**Georgia-Pacific Corporation
Big Island, Virginia
Project XL
Amendment to Final Project Agreement**

AMENDED SECTIONS

The following sections of the original FPA are being amended. The language of the original FPA being modified is designated in ~~strikethrough~~ mode and the amended language is shown in ***bold Italics***.

Relative Project Timeline

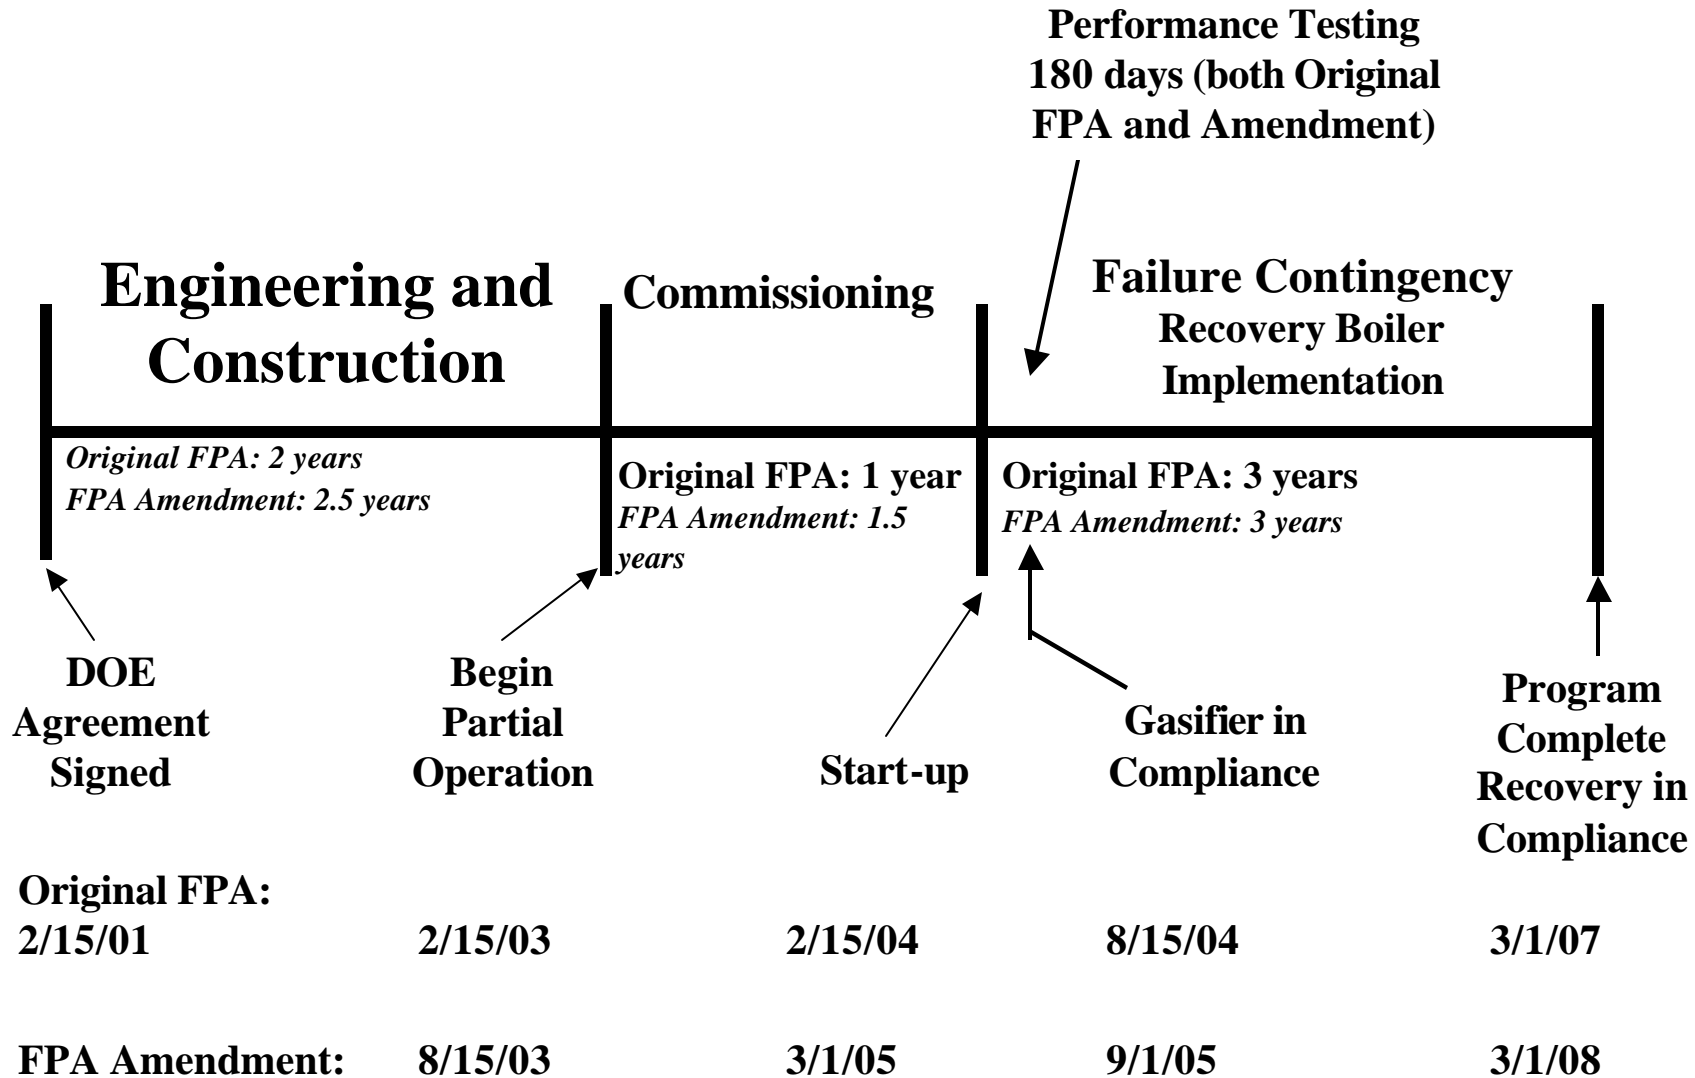
To reflect the anticipated schedule changes discussed above, a new Schedule and Milestones chart is shown in Appendix 1.
